PORT OF TACOMA

TOTE MAINTENANCE BUILDINGS 9, 10

ROOF REPAIRS

PROJECT NO. 201064.01
CONTRACT NO. 071099

DETAILS - BUILDINGS 9, 10

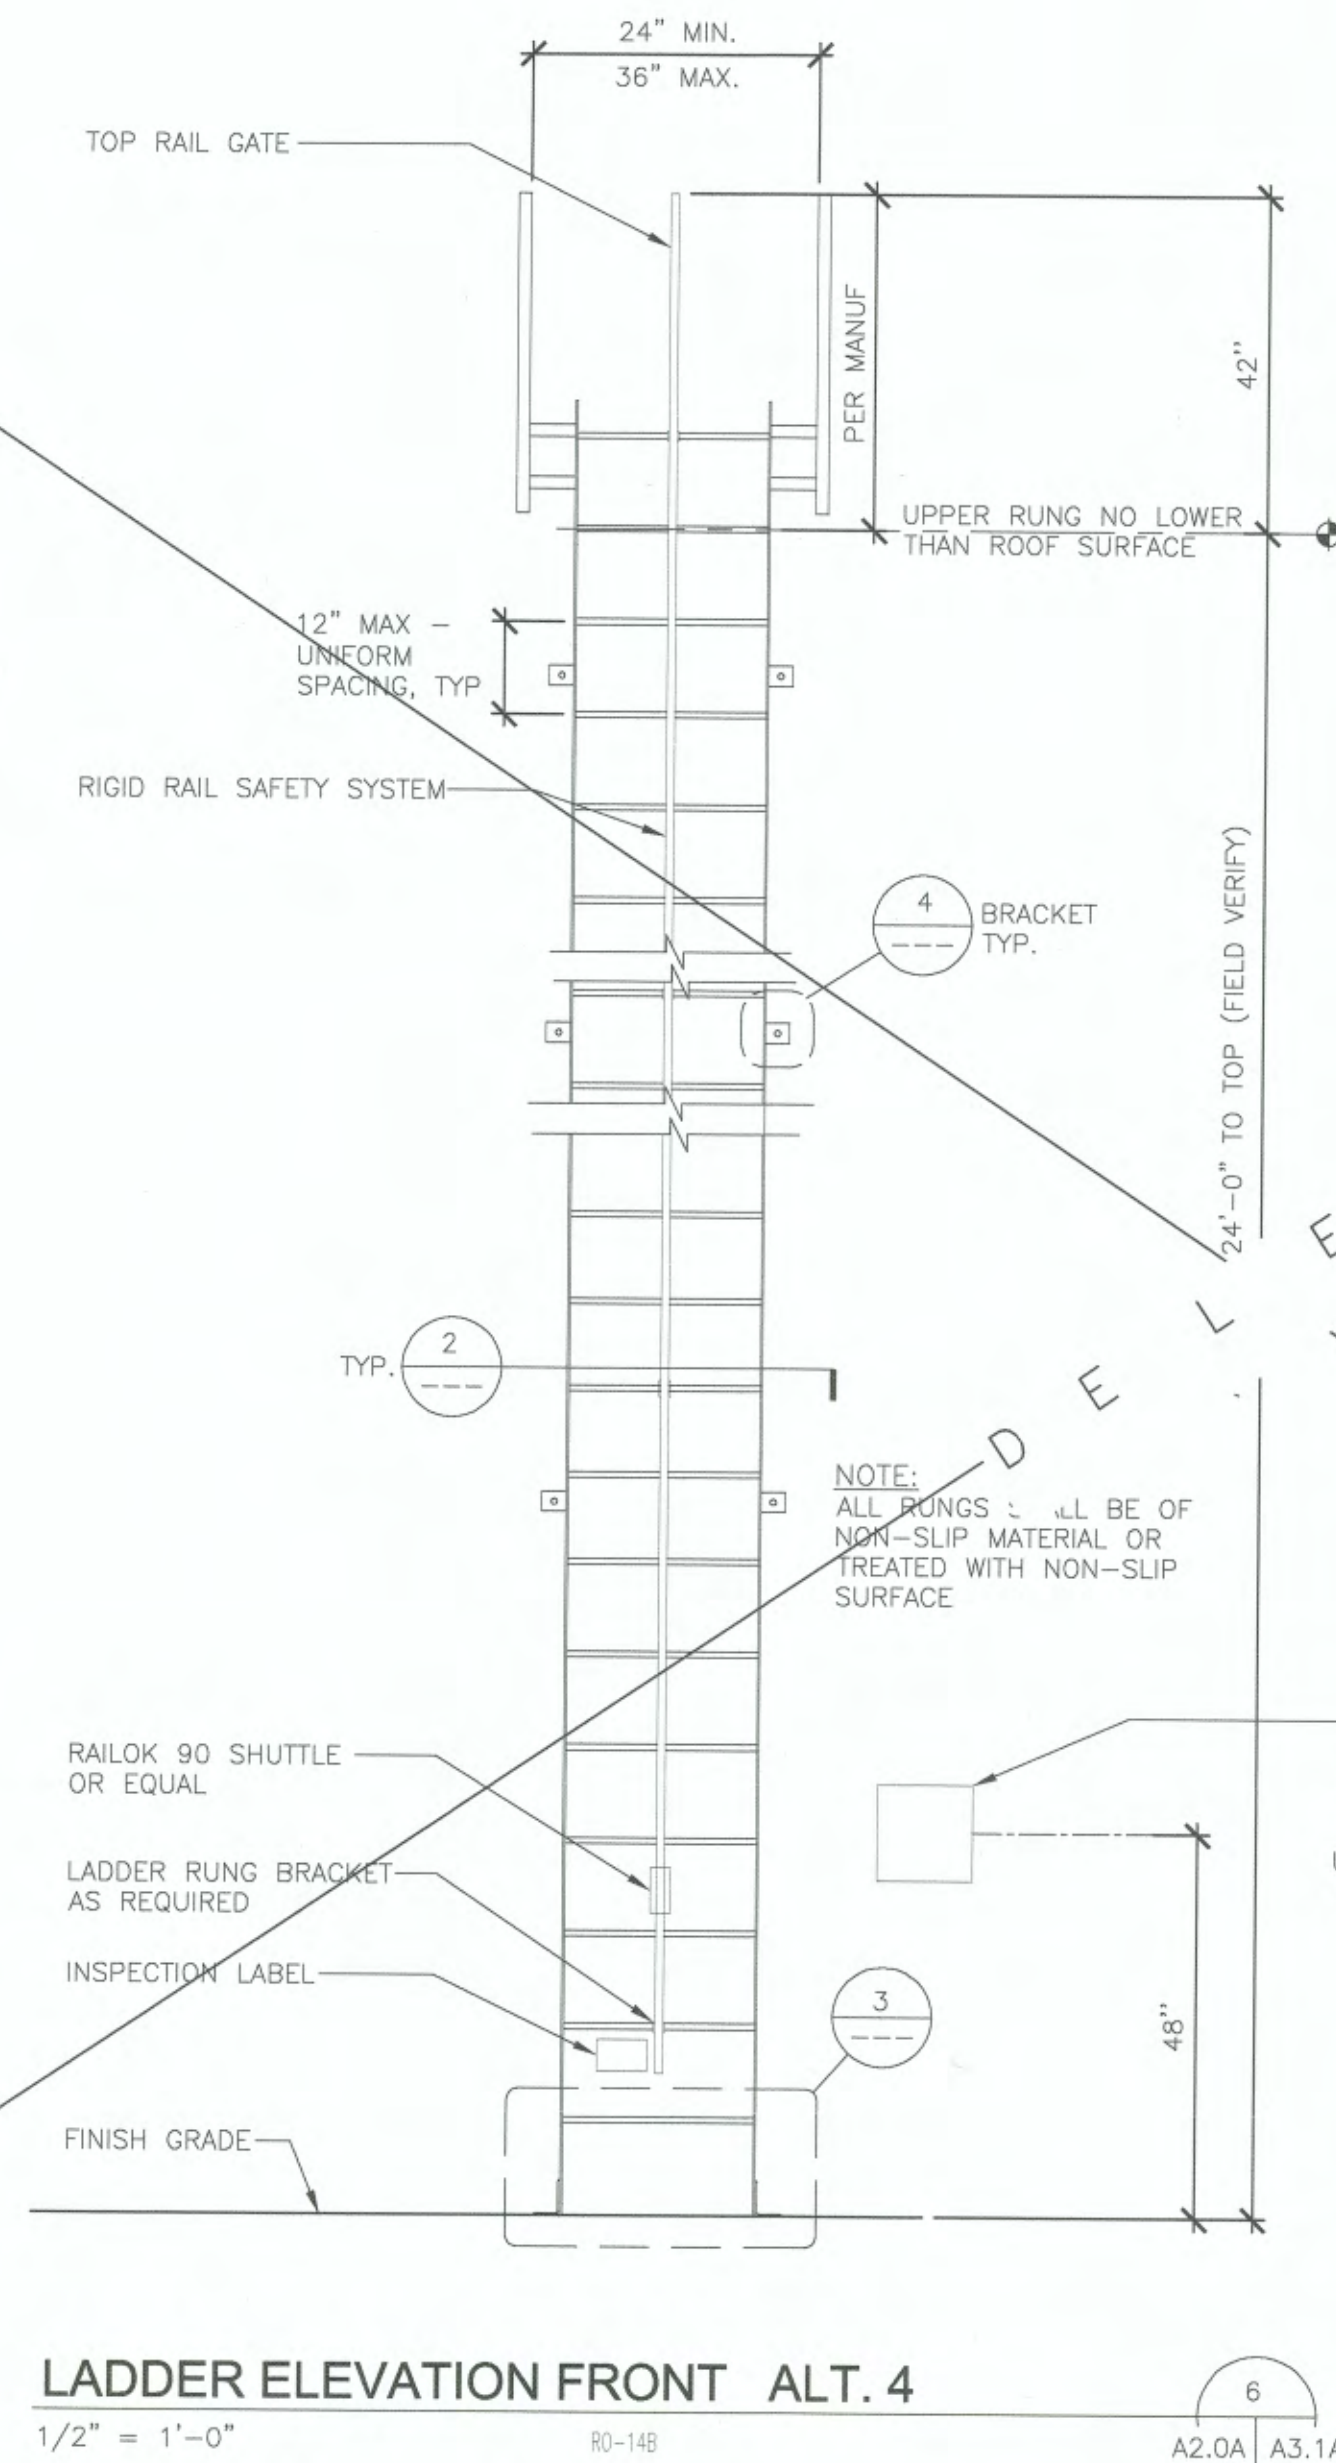
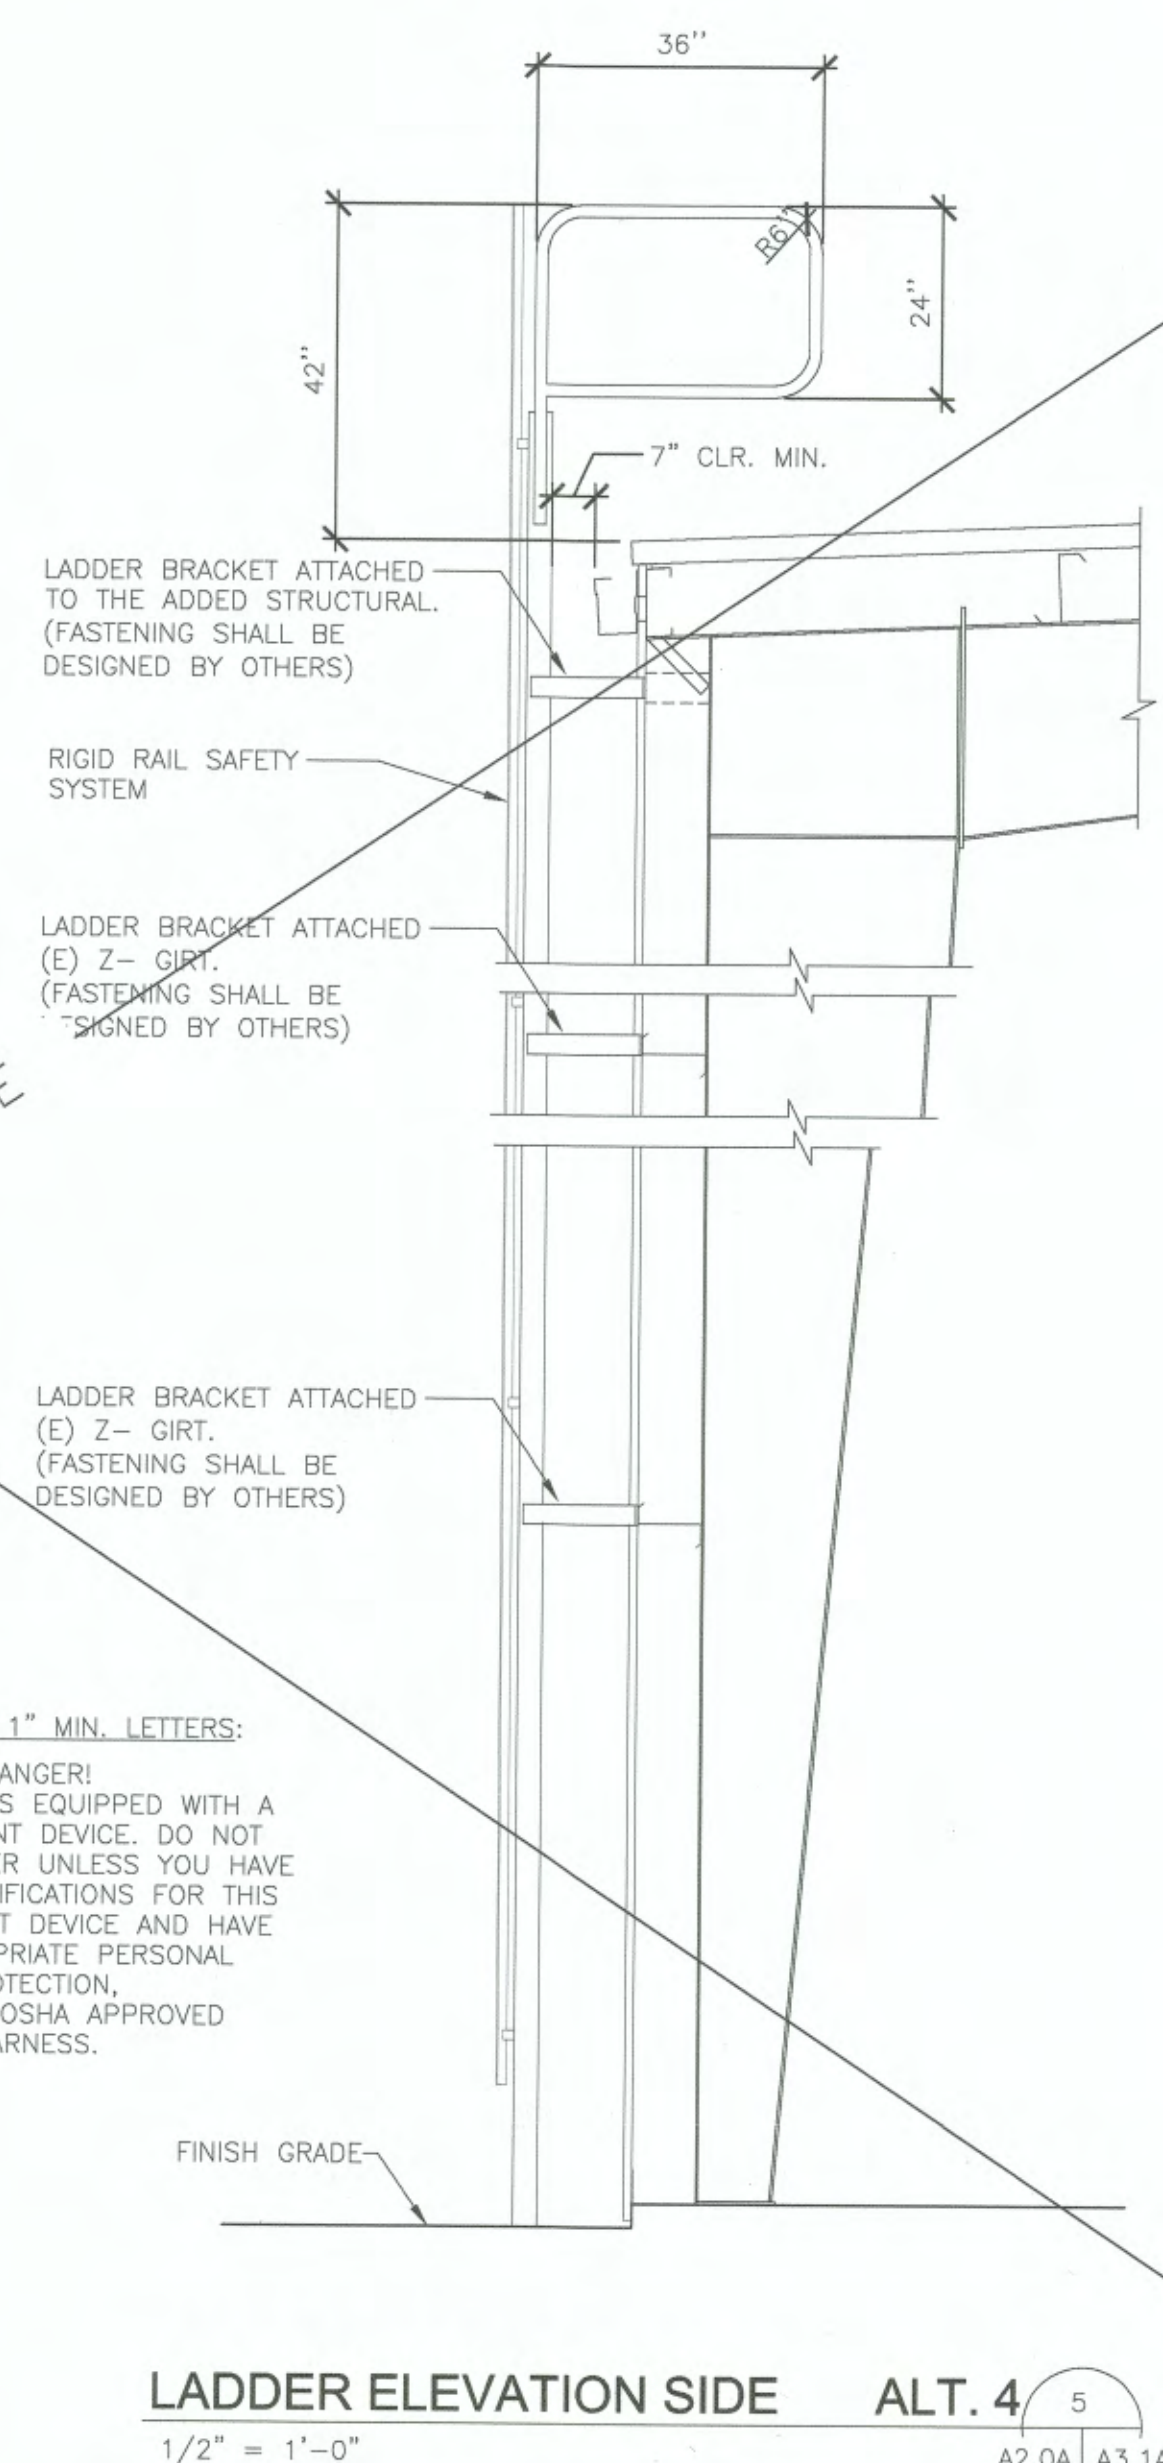
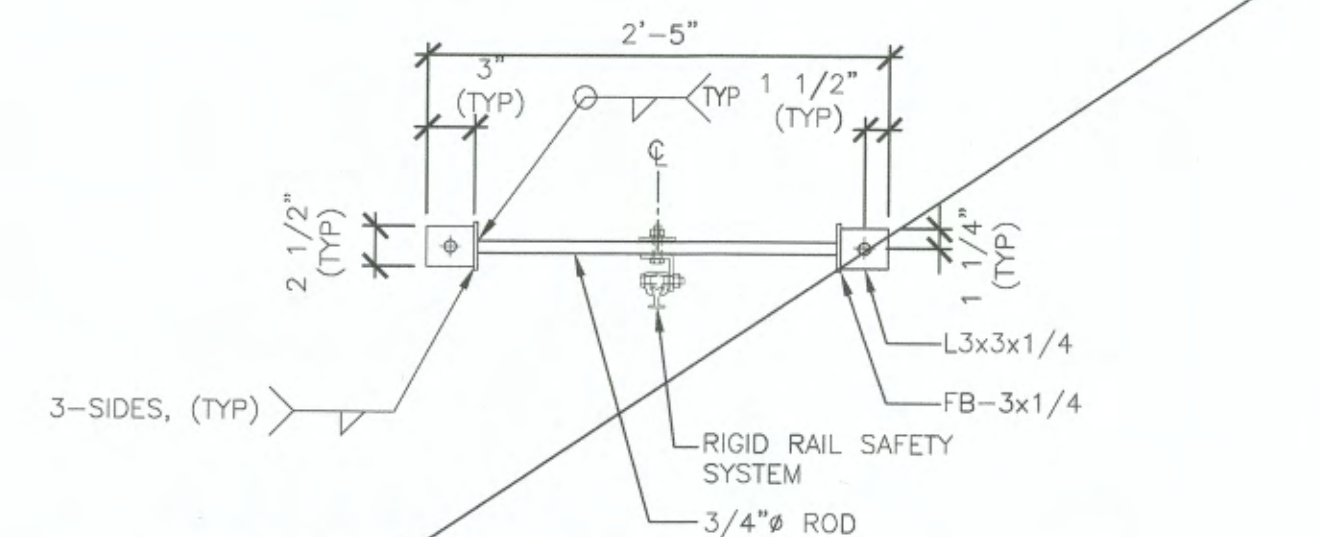
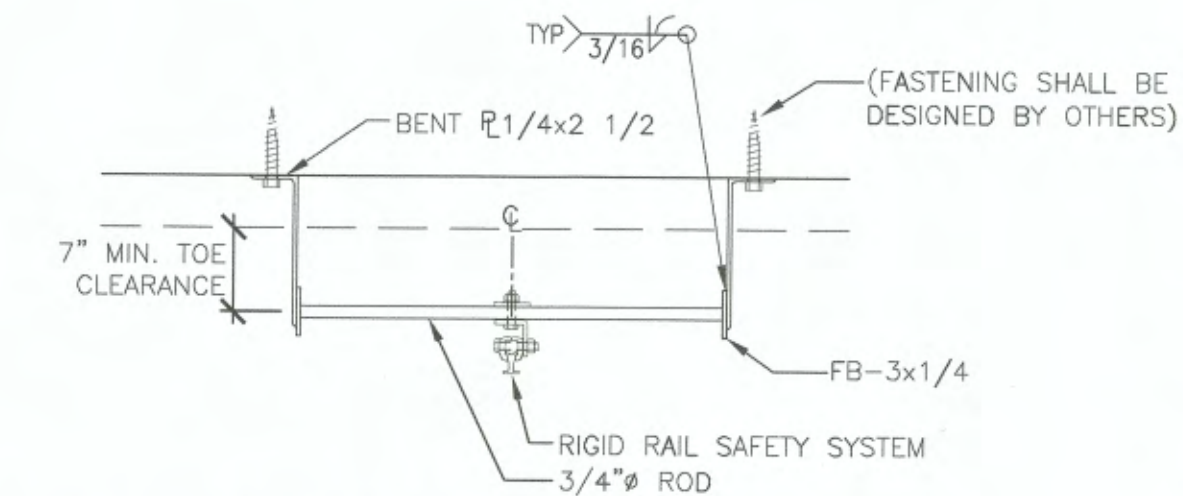
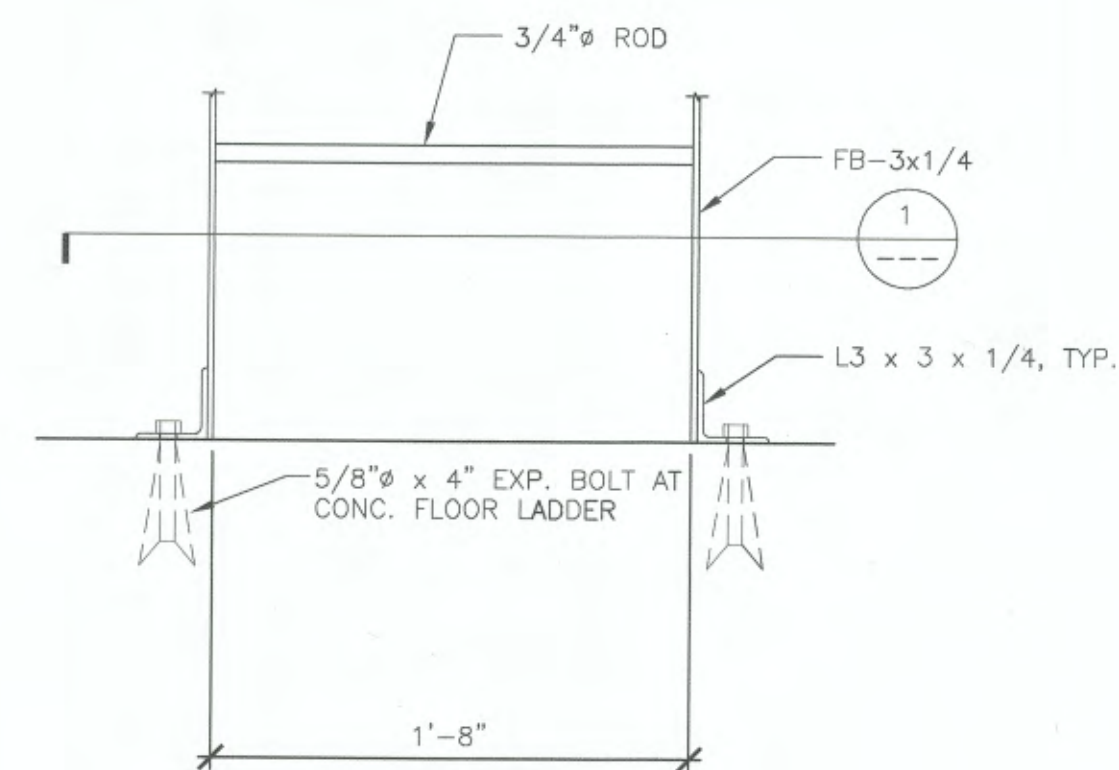
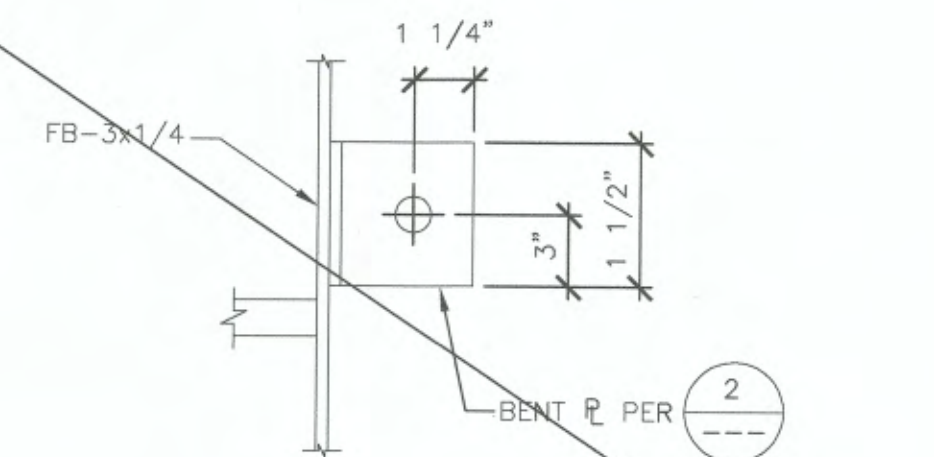
~~LADDER SECTION~~ A ALT. 4

6605
~~AC-1A~~
DELETE
